MARA ROAD EXTENSION

ADDENDUM #1

JANUARY 5, 2023

THRASHER PROJECT #101-T30-11030

PLAN/PLAN - MARA ROAD - STA. 19+50.00 TO STA. 26+93.34

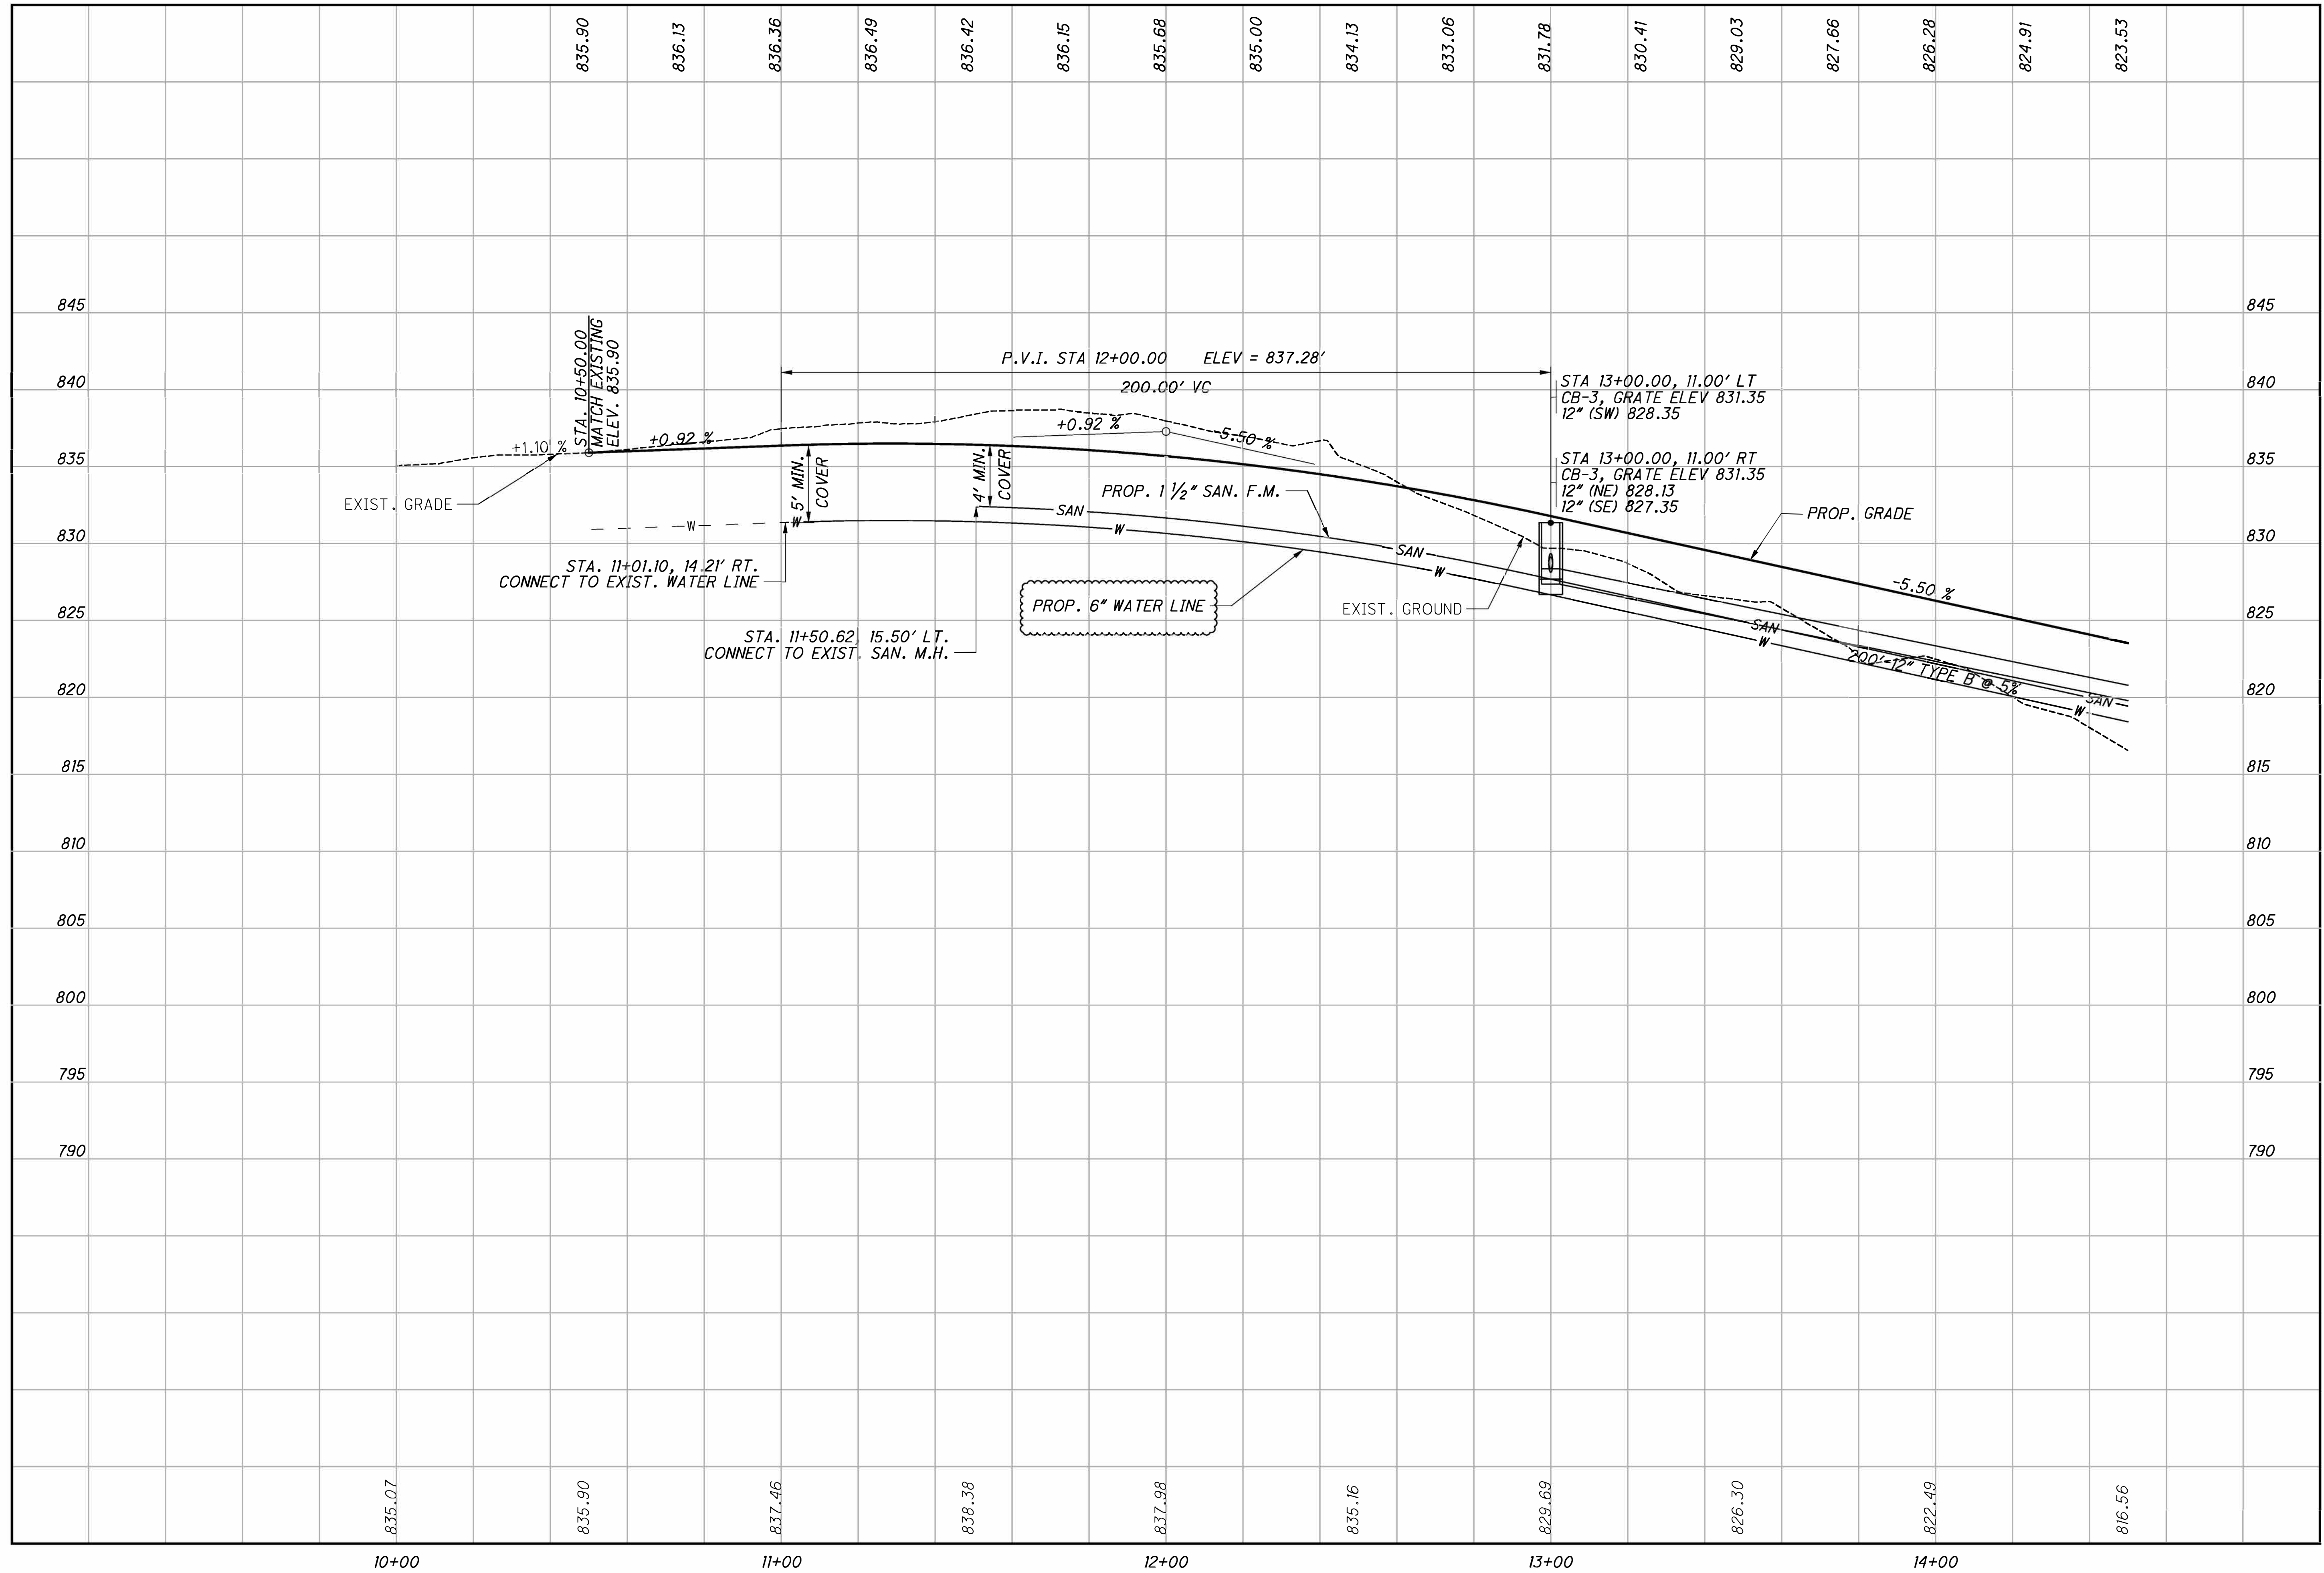
5. *On drawing # 7 the plans show a 1-1/2" force main and a 2-inch air release, how are we to connect this?*

6. *On drawing # 7 the plans show 5 air release valves and in the bid items there are only 1 each. How many of these are needed?*

13. *On drawing # 7 the water tie in shows the existing waterline ending and us tying into it. The detail shows a tee connecting to a valve, how is this tie in supposed to be installed?*

30. *Can a drawing be supplied showing the total construction limits? Sheet 7/50, from Sta 13+00 to 16+00 the construction limits are off the sheet.*

38. *Sht 7/50, The plans indicate 5 each - 2" Air Release Valves. Bid quantities are 1 each.*

Air release valve has been revised to 1 1/2".

Quantity has been revised to 5 each.

There is not sufficient room to show the extent of the construction limits on the sheet. Please see cross sections for grading information.

Air release valve has been revised to 1 ½". Quantity has been revised to 5 each.

PLAN VIEW - TITANIUM WAY
STA. 97+00.00 TO STA. 102+00.00

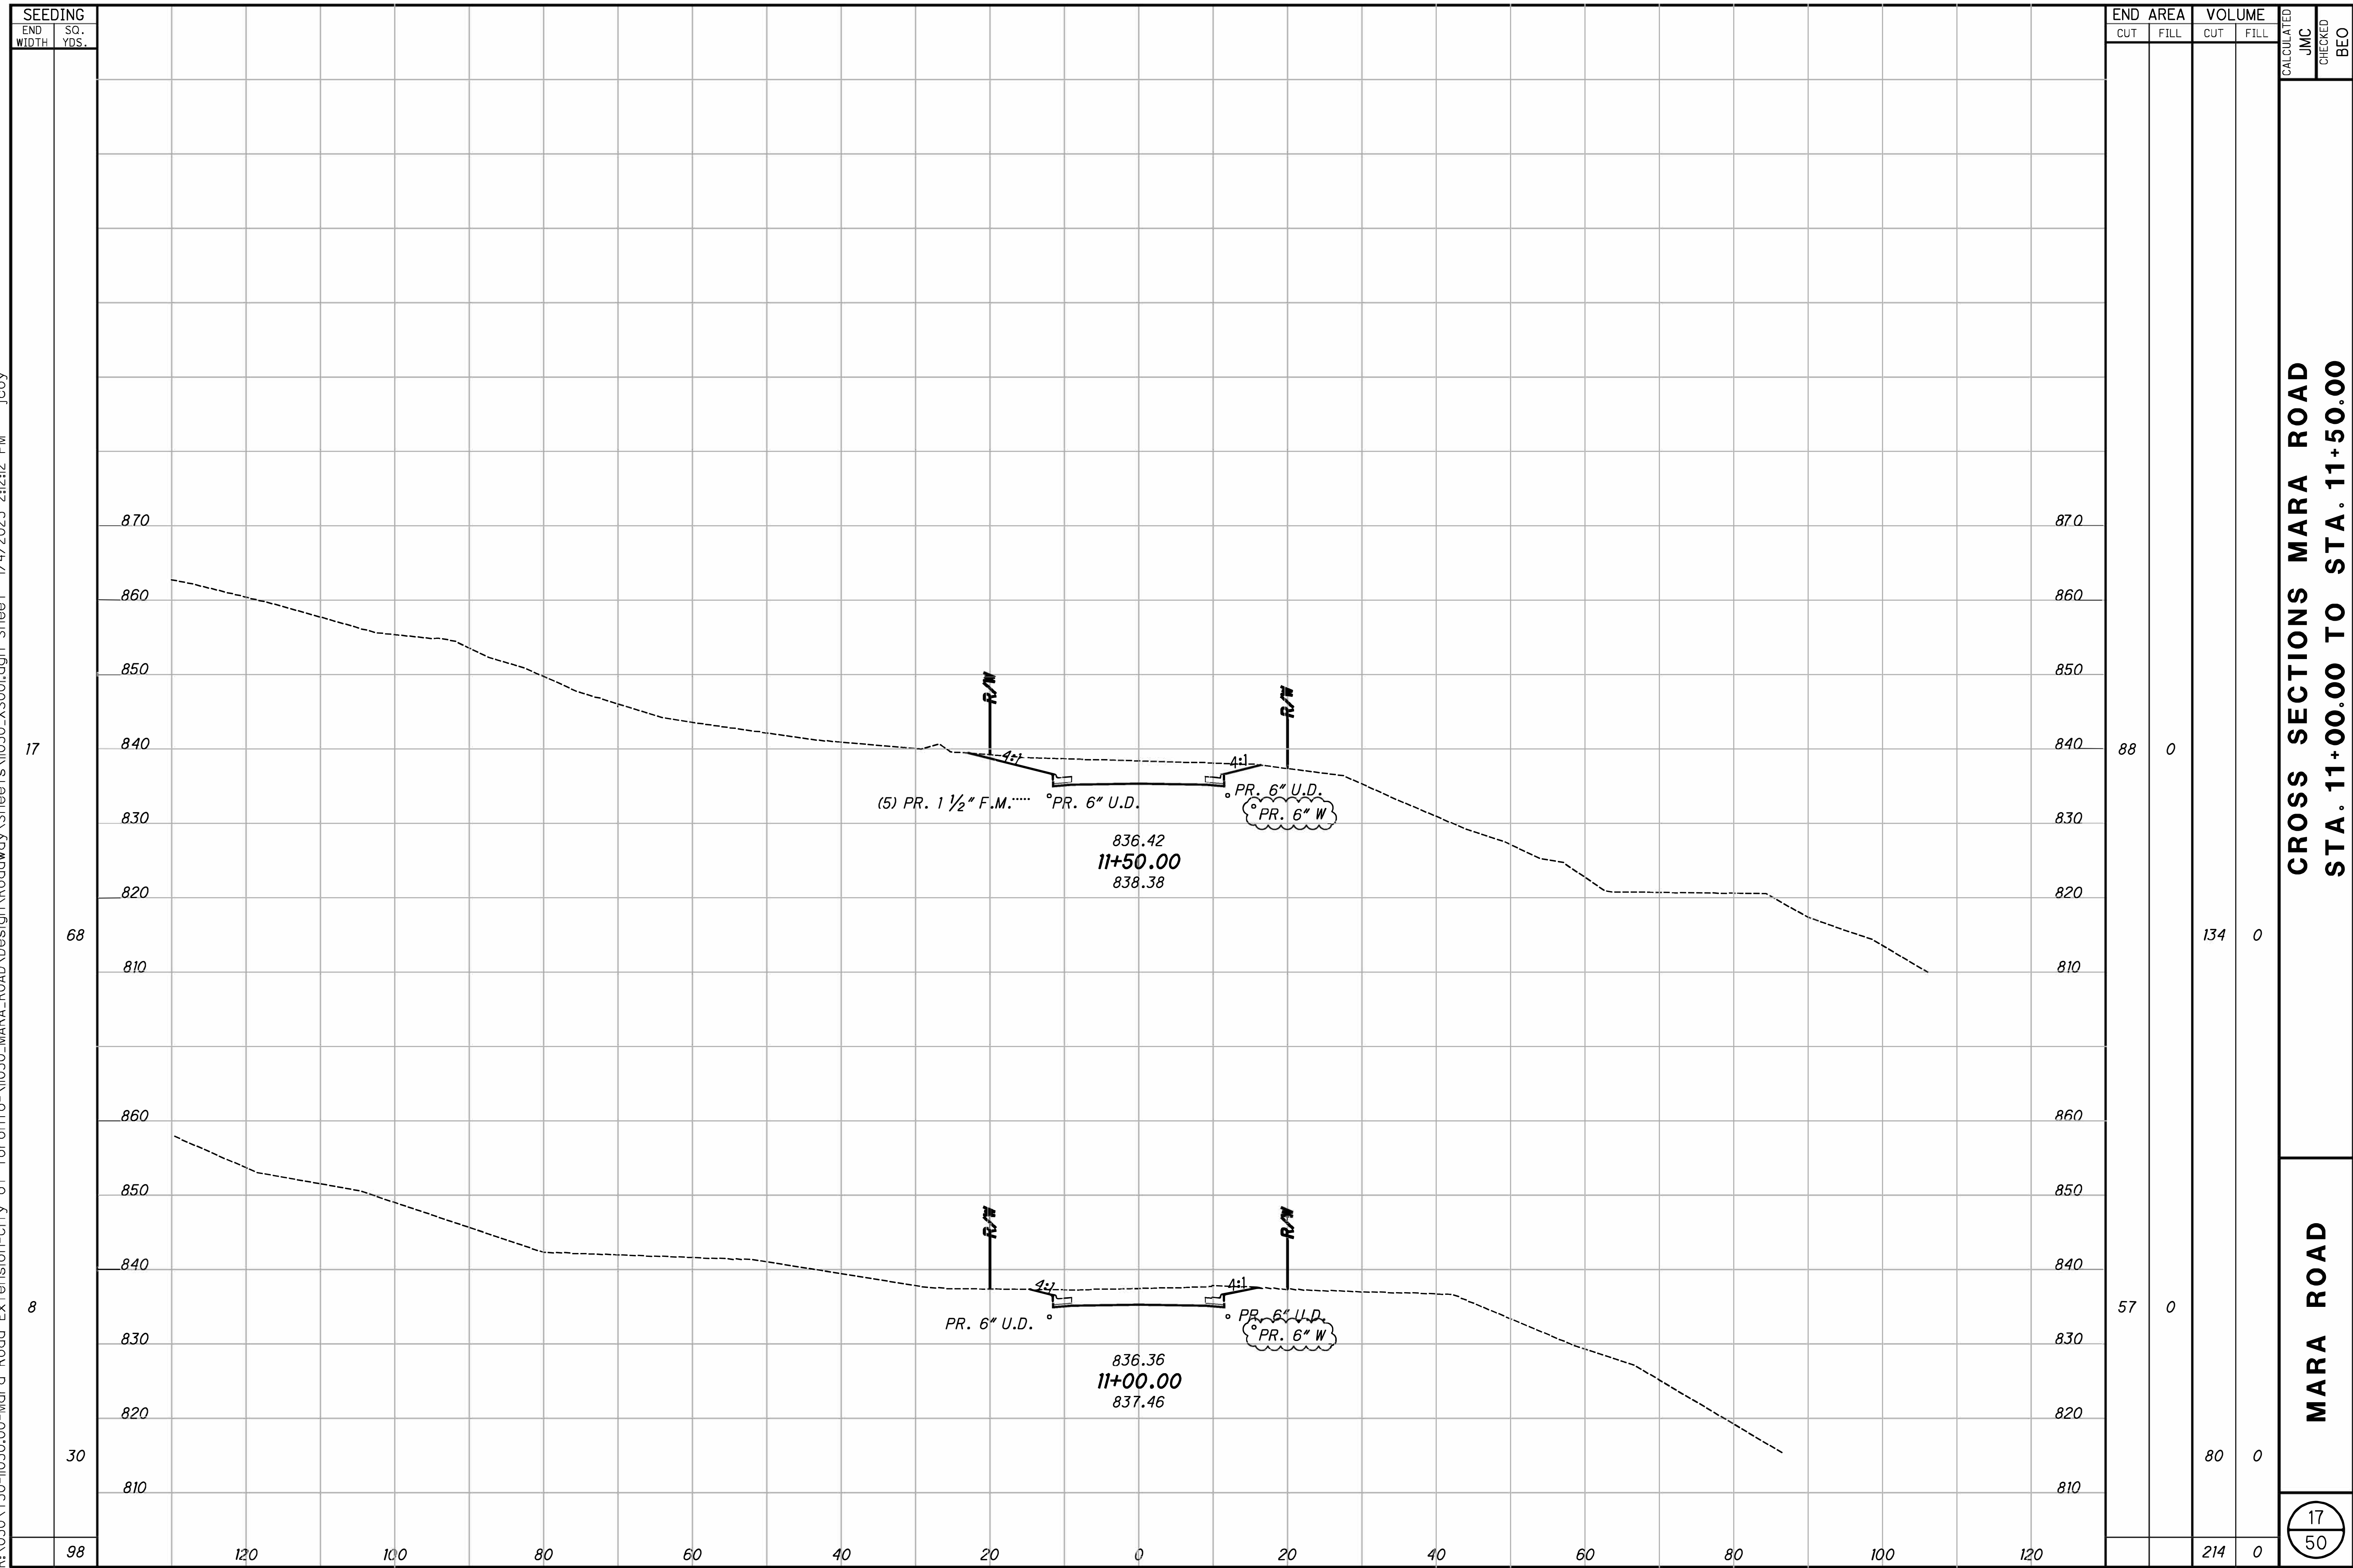
1. *Please clarify the trench detail on sheet 13/50. The detail shows 5' limit of pavement replacement from centerline of pipe, but also shows 10' additional replacement on each side of trench.*

28. *Is the pavement detail on sheet #13 (for the asphalt replacement on Titanium Way) supposed to extend beyond the trench 10 feet or 10 inches on either side?*

42. *Sht 13/50, Pavement Repair Detail – The Saw Cut is shown as 10' on either side of the trench. Is this correct?*

The reference to 10' is a typo. The measurement has been revised to 1'.
